**Appl. No.** : **09/196,658**  
**Filed** : **November 19, 1998**

### **AMENDMENTS TO THE DRAWINGS**

METHOD D APPARATUS FOR RECEIVING GPS/GLONASS SIGNALS

FIG. 5

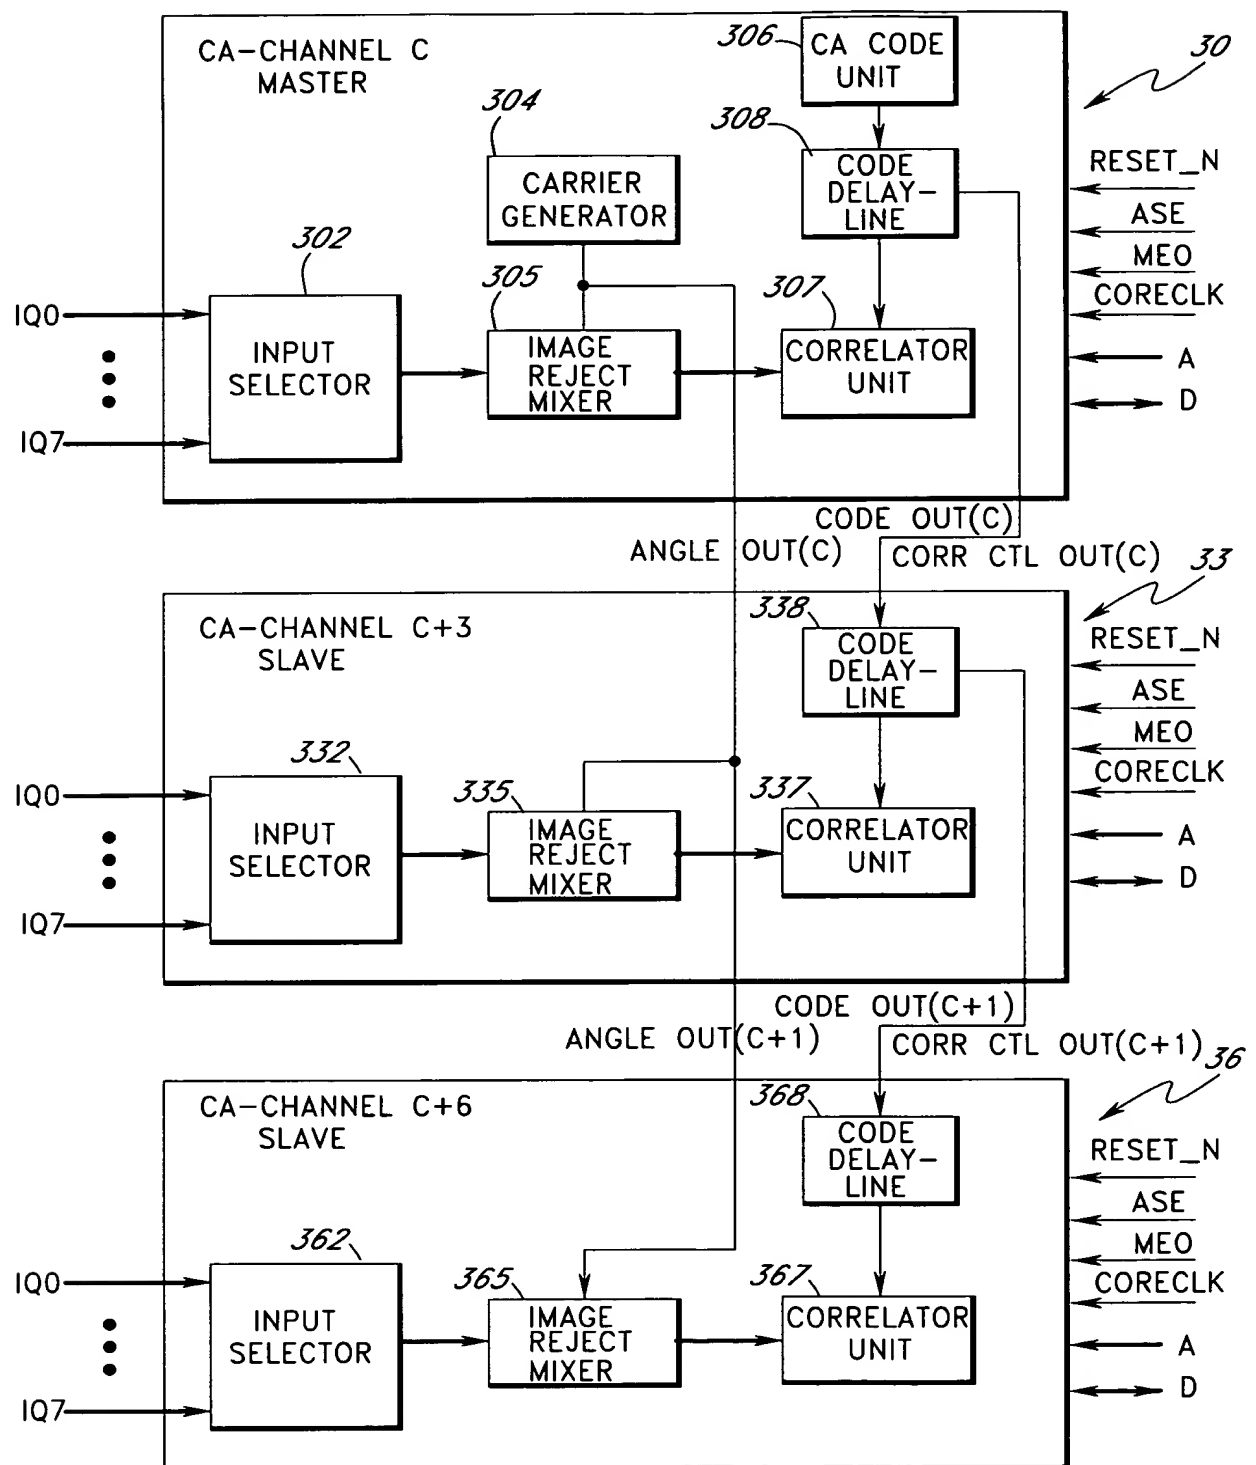
The attached sheets of drawings include changes to Figures 5 and 6. Each of the sheets, which includes Figures 5 and 6, respectively, replaces the original sheets including Figures 5 and 6, respectively. In Figures 5 and 6, the signals IQ and IQ7 have been amended to "IQ0-IQ7." In Figure 6, the correlator units 317 and 327 have been amended to the correlator unit (L1 demodulator) 317 and the correlator unit (L2 demodulator) 327, respectively.
